<b>Project Title</b>	Italian Hospital, GOSH
<b>Report Title</b>	External Materials Schedule
<b>Report number</b>	1615-ST-XX-XX-RP-A-7130
<b>Date</b>	22.05.19
<b>Status / Revision</b>	A2
<b>Date of Revision</b>	28.10.19
	Sign off refers to acceptance of samples reviewed on site with Jonathan McClue and Nick Baxter on 27.03.19 & 21.05.19

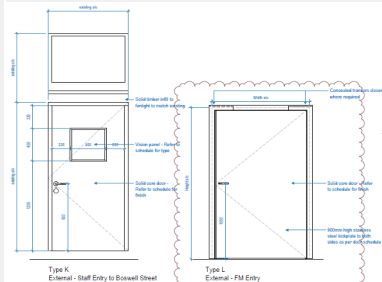
2.7 Type N1 Plant compounds and over third floor infill by party wall	45-35-22/ 355 Bird deterrents <i>Net bird deterrents . Hanging Bird control system</i>	Hanging nylon net	No sample provided		Image/brochure/web Link should be sufficient   <b>Kier</b> Please see attached photo of bird mesh that Kier will replicate as per the adjacent propoert Barclay House:

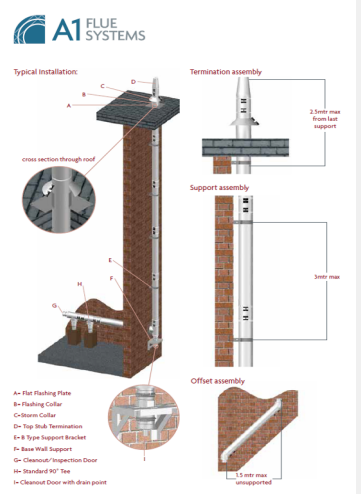
<b>3.6 General</b> New metal windows - to match curtain walling	25-50-95/125: Window system (new metal) type X	RAL 7021	No sample provided	n/a	<b>Image/brochure/web Link should be sufficient (applied to 3.4-4.3)</b>	<b>Kier</b> See below image from the Schueco website for the type X window: <a href="https://www.schueco.com/web2/de-en/architects/products/windows/aluminium/schueco_aws_70_sl_hi">https://www.schueco.com/web2/de-en/architects/products/windows/aluminium/schueco_aws_70_sl_hi</a>
